Municipal Planning Commission AGENDA Monday, July 1, 2024 — 6:30 p.m. Bartlett City Hall Assembly Chamber

Tuesday, July 1, 2024 - 6:30 P.M.
Bartlett City Hall Assembly Chamber
Staff Comments

1. Flex Space, Northwest corner of Summer Avenue at Altruria Road (Vanessa Ballard, V Ballard Consulting)

TREE PROTECTION ZONE - 4' HIGH TREE

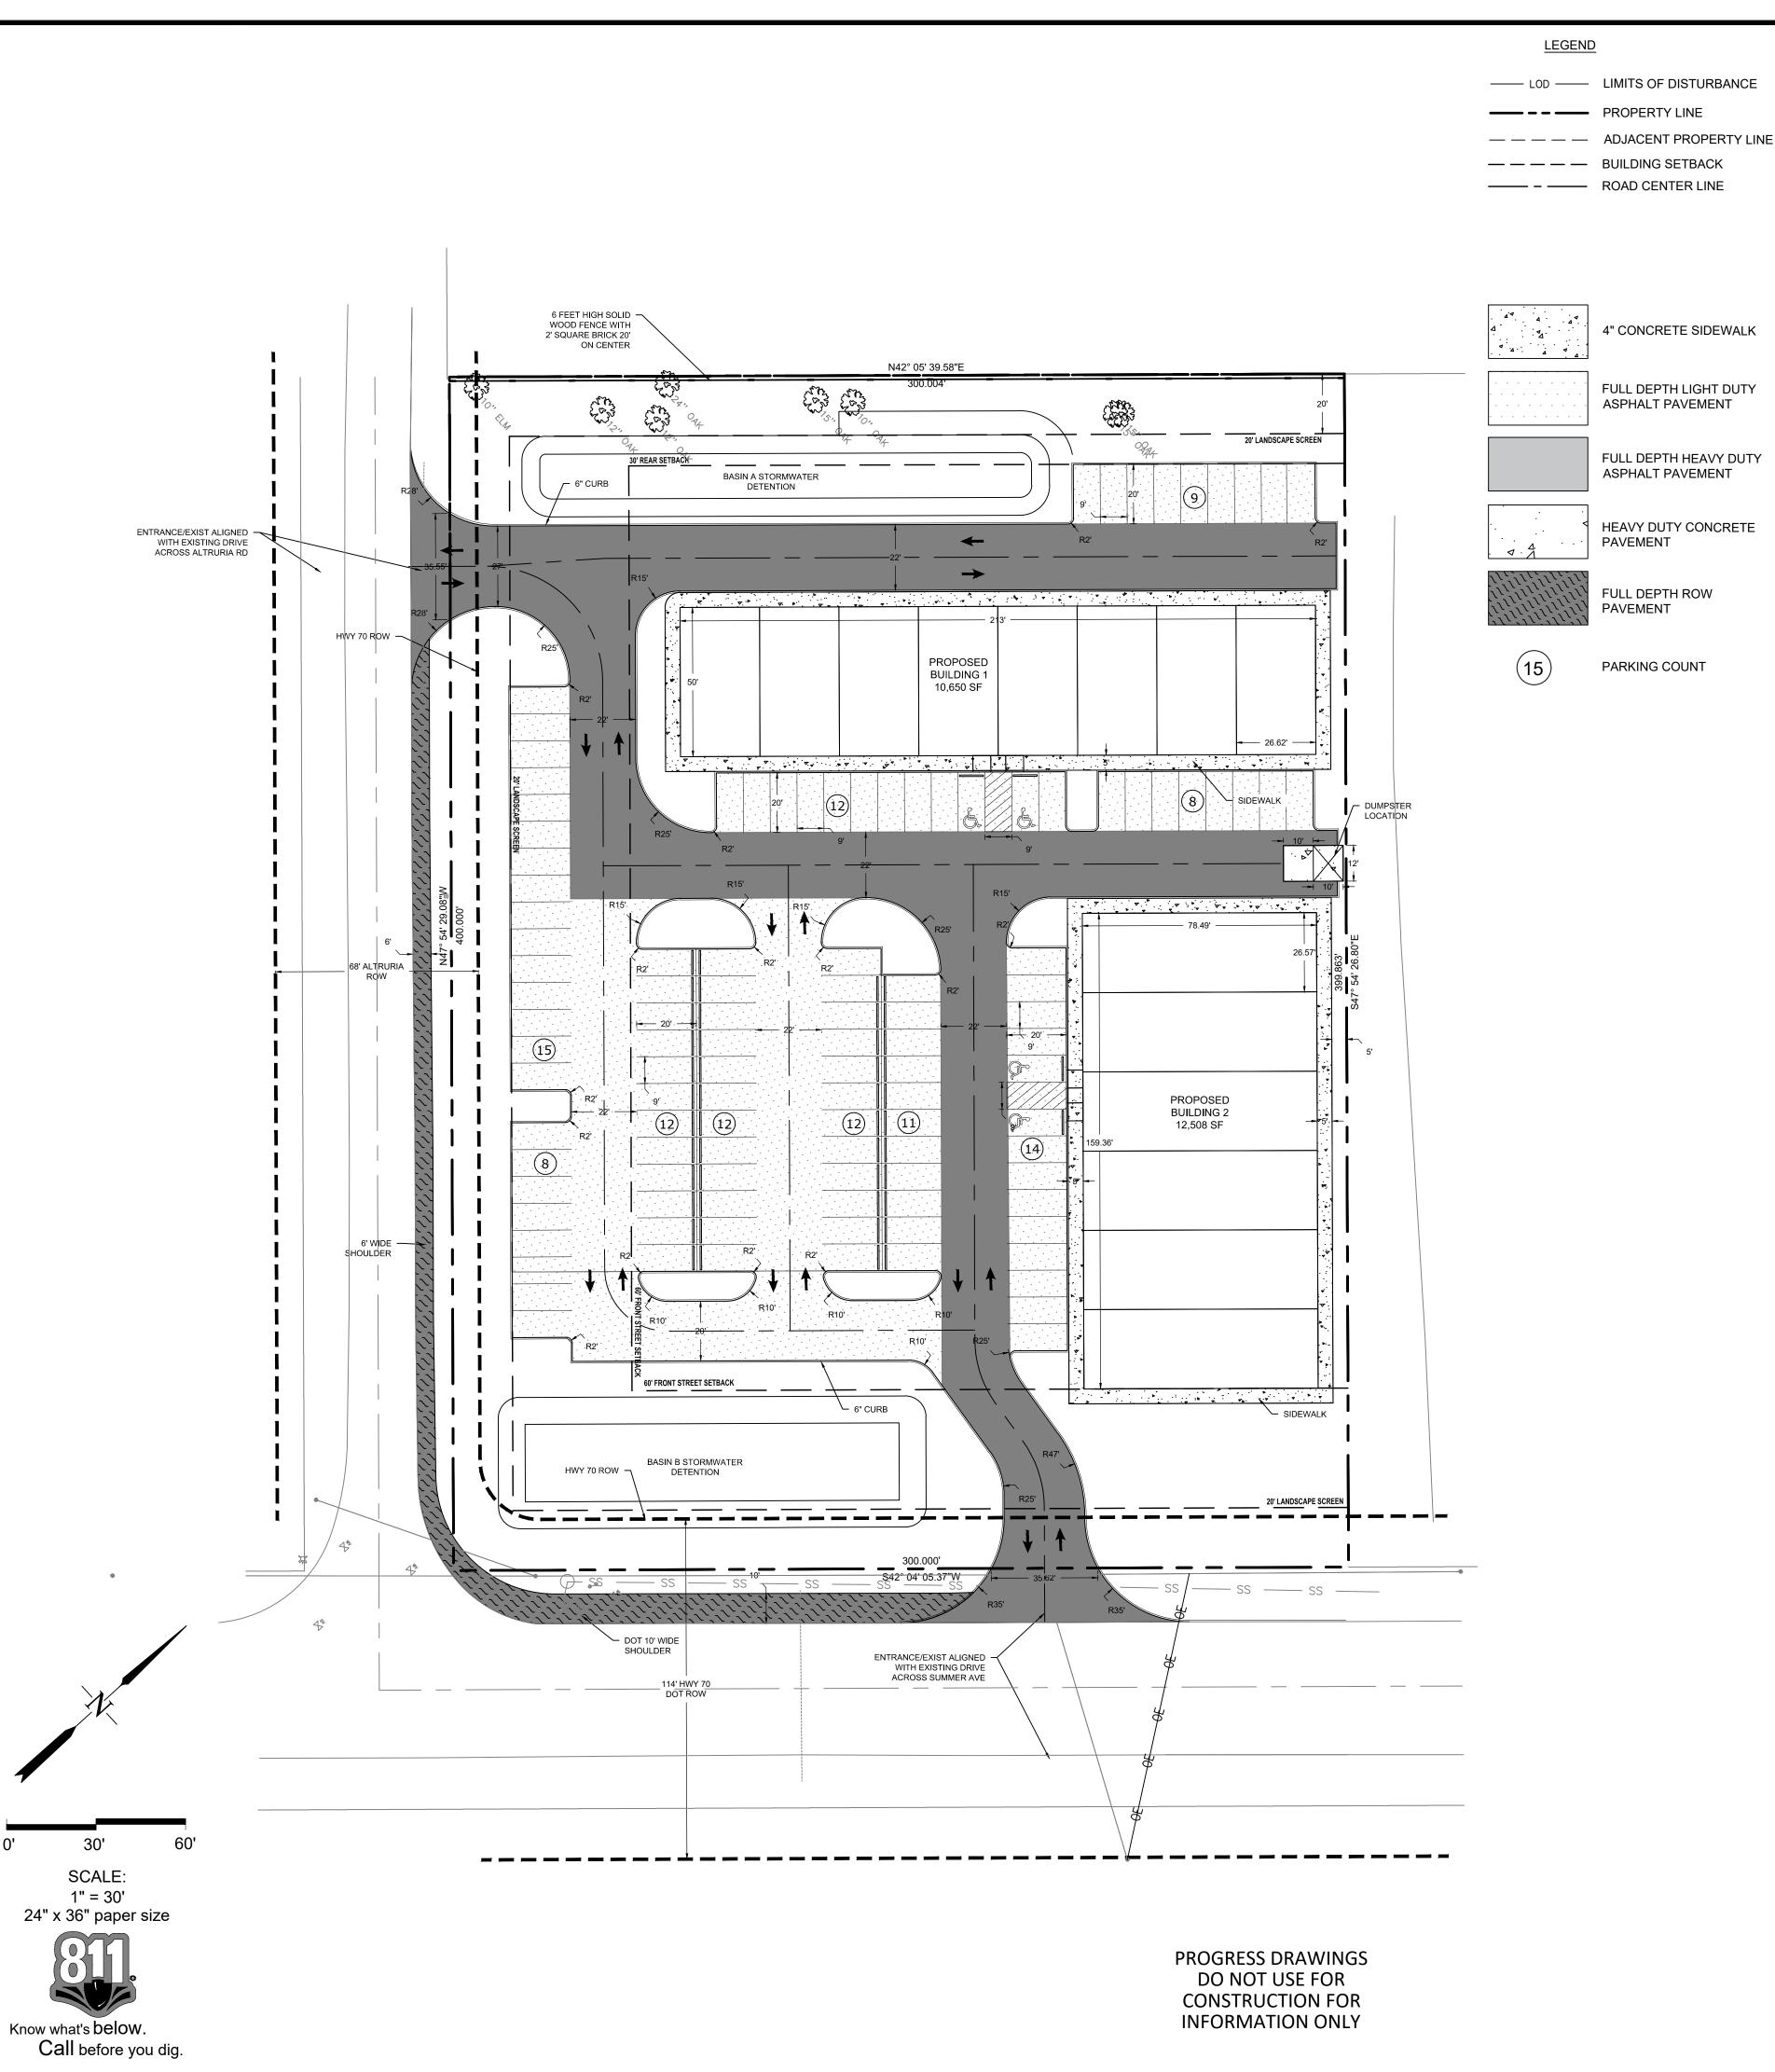
7. Some trees shown as to be removed in the tree table are nor marked to be removed on the plan.

GRADING PLAN

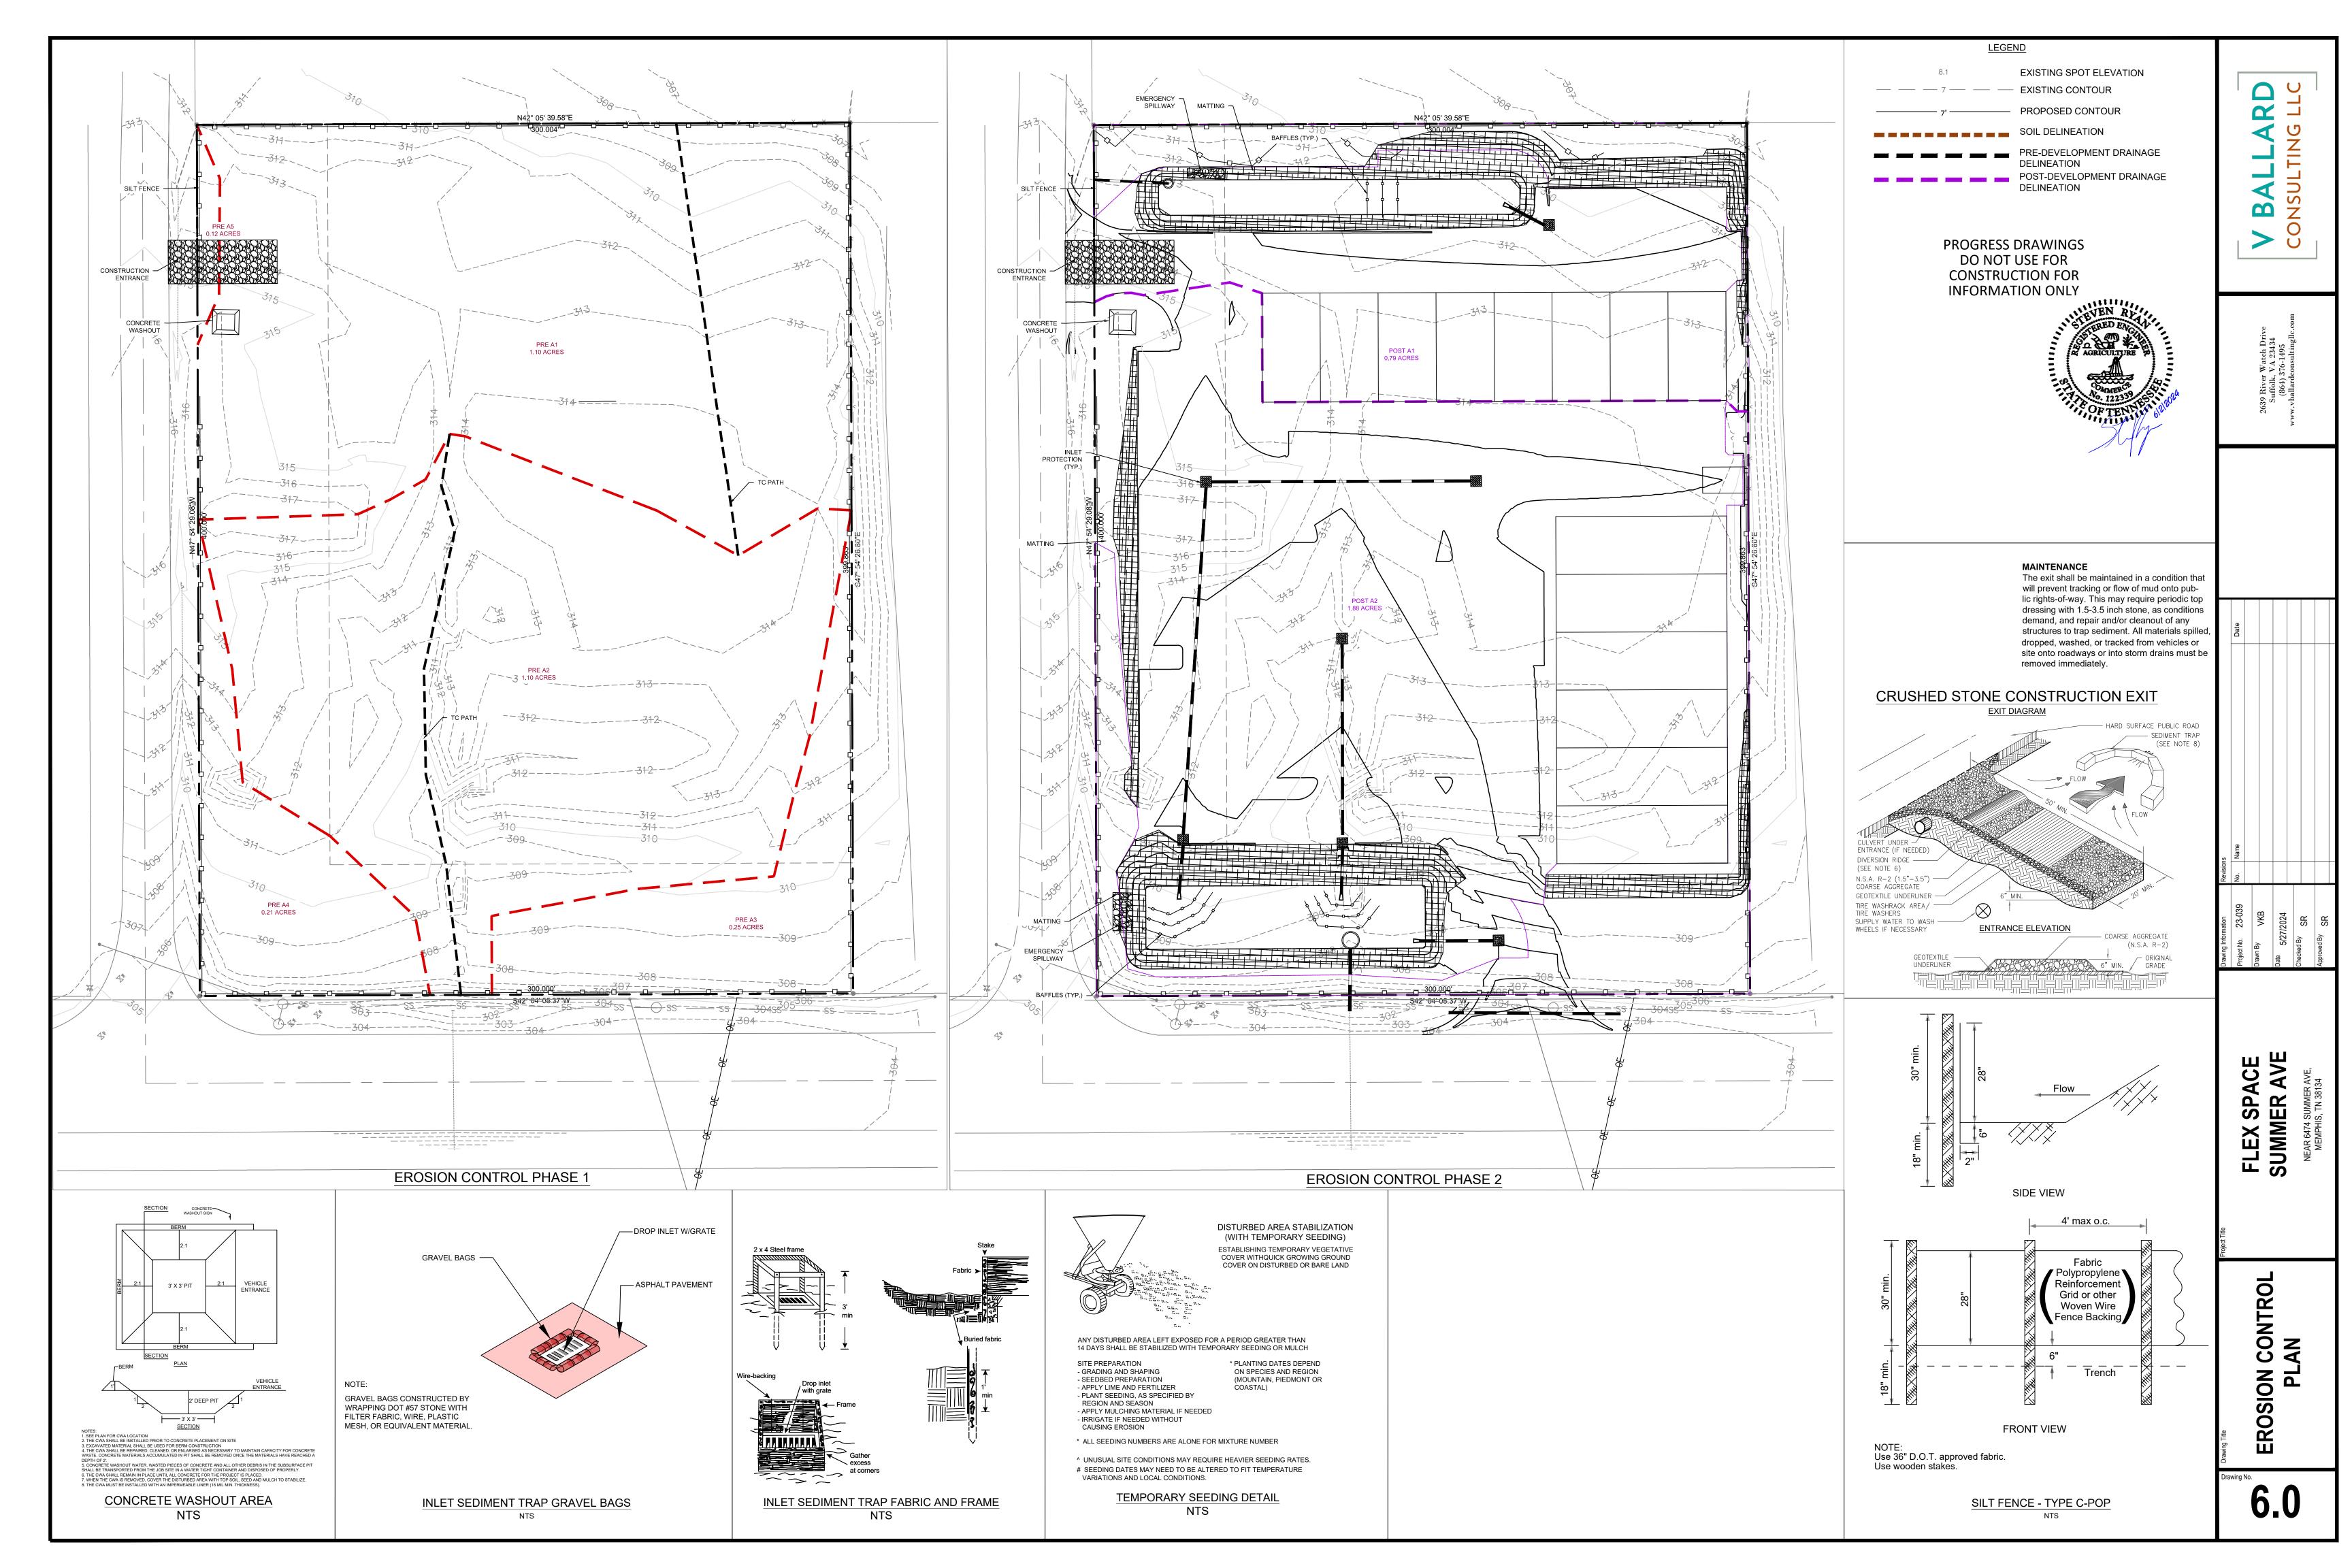
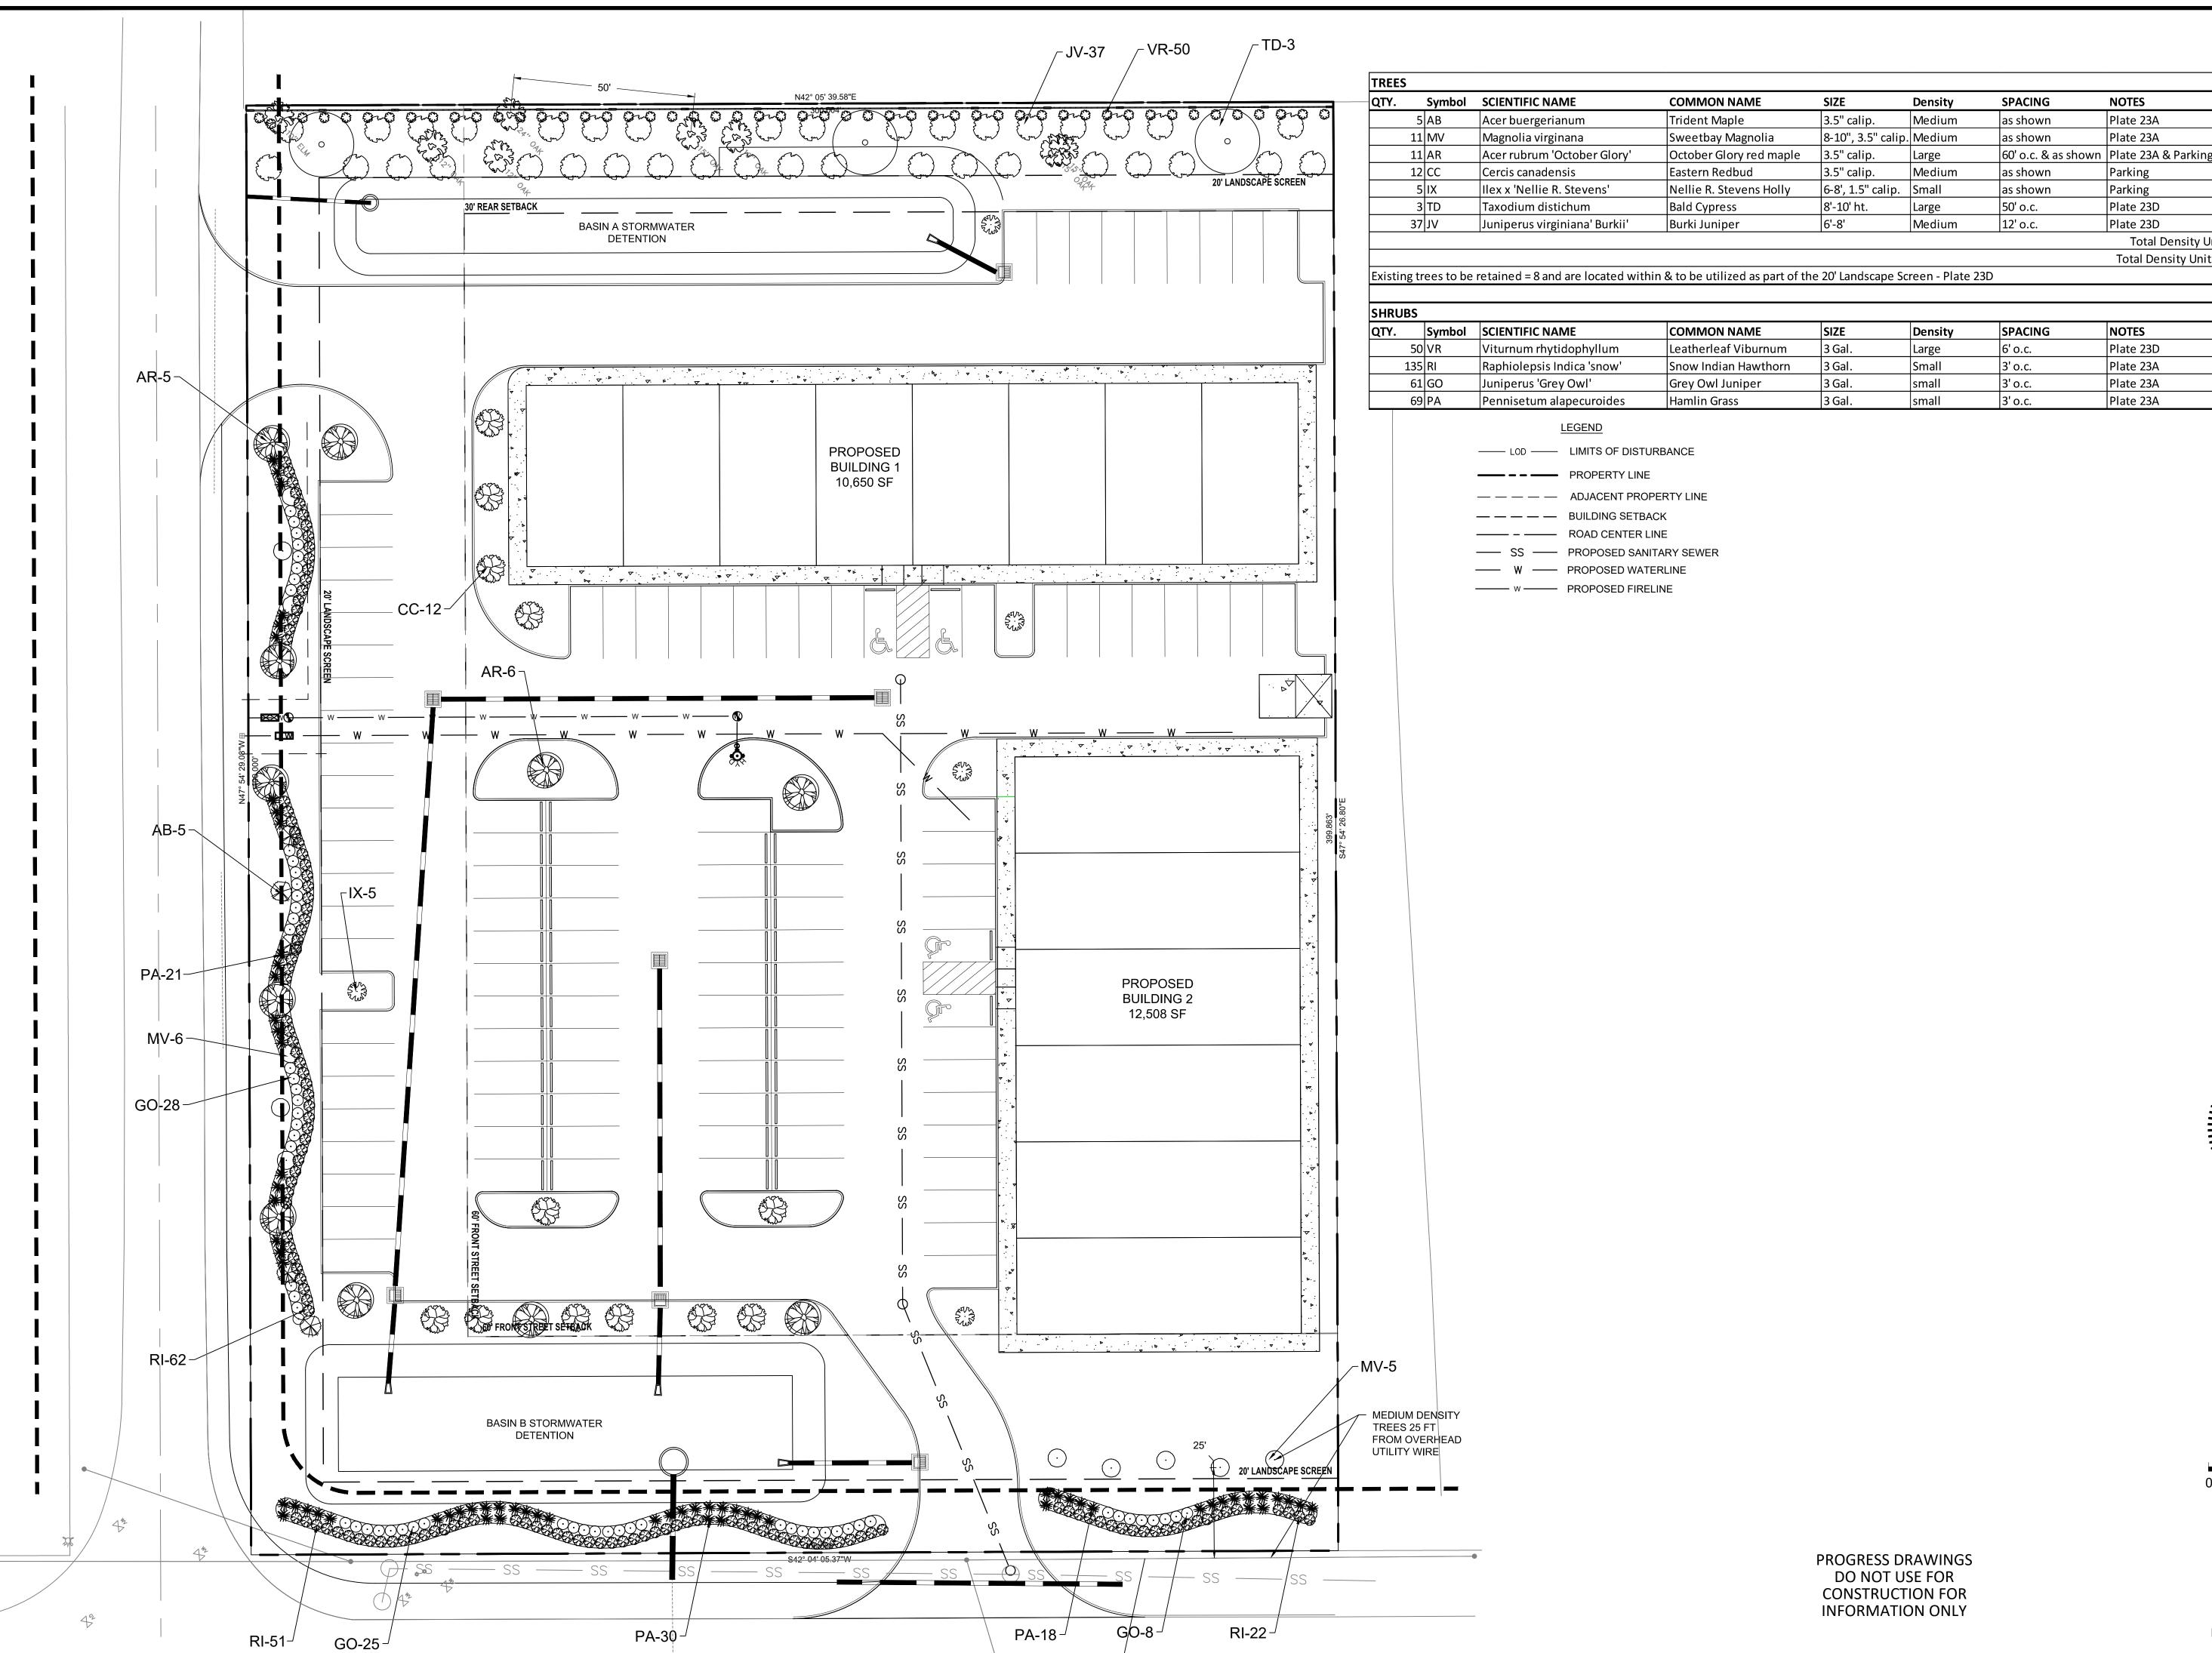
- 22. Need details for drainage structures.
- 23. Show locations of emergency spillways.
- 24. The detention basin calculations shall be shown on the plans. As-builts of these will be required after construction.
- 25. A structure table and pipe table must be labeled to show public and private drainage lines.
- 26. The outlet pipes from Basin B1 shall be tied to an area inlet structure and connected to the existing 24" RCP under HWY 70 to reduce overland flow.
